City of Madison, Wisconsin

REPORT OF: URBAN DESIGN COMMISSION PRESENTED: July 27, 2016

TITLE: 418 Division Street – Rezoning and **REFERRED:**

Conditional Use for a Proposed 31-Unit Apartment Building. 6th Ald. Dist. (43725) **REREFERRED:**

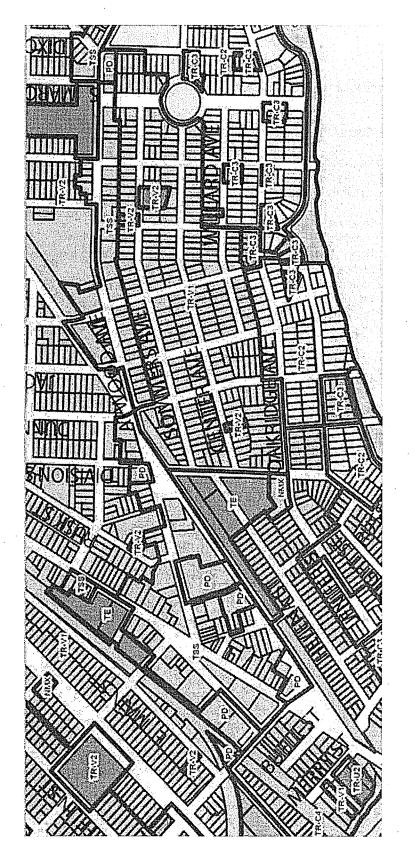
As the map on the next page reflects (part of the City's Zoning Map), surrounding properties are primarily comprised of TR-C3 (single family detached) and TR-V2. The nearby TSS all fronts on Atwood with entrances on Atwood, or through the parking lot further west.

The proposed building is not compatible in scale. Other than the surrounding Schoep's buildings at one to two stories, the surrounding properties are primarily one and two story single family homes.

There is not any interaction with the public bike path -- other than re-grading the area to make it more flat. The sidewalk to entrances along the bike path is on the property line.
